43 – 61 Turner Road Data Centre

Submissions Report

SSD-68013714

2 July 2025

Figure 4-1 Swept path analysis for site access points

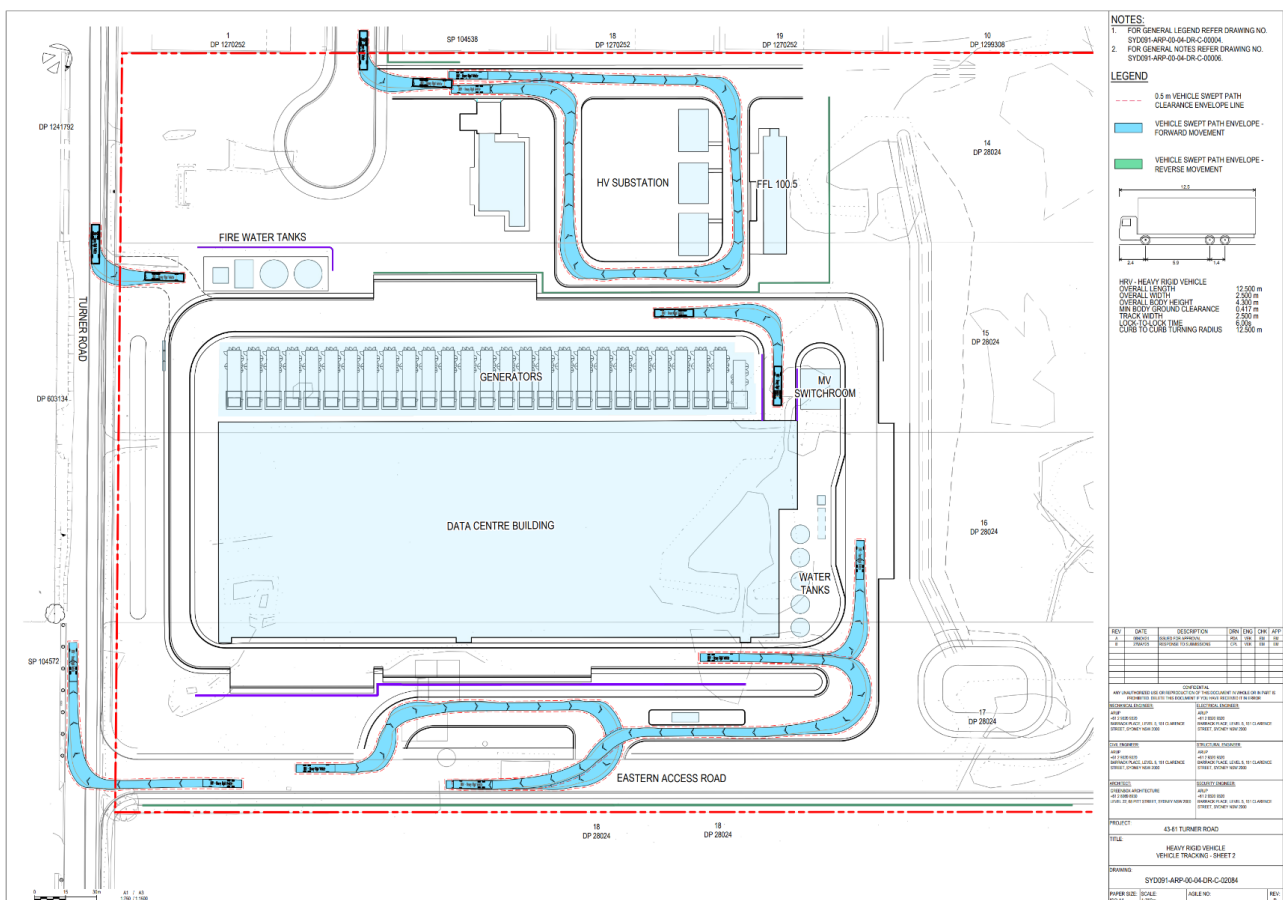
Additional swept path analysis should be provided to demonstrate all site access points, including vehicle access off Turner Road and the substation access point, can provide for entry and exist of all types of vehicles, including the emergency vehicle.

Swept paths for all access points is shown in Figure 4-1 below and provided in Appendix D. The swept path analysis demonstrates that all access points to the site can provide entry and exit for all vehicles up to and including heavy rigid vehicles.
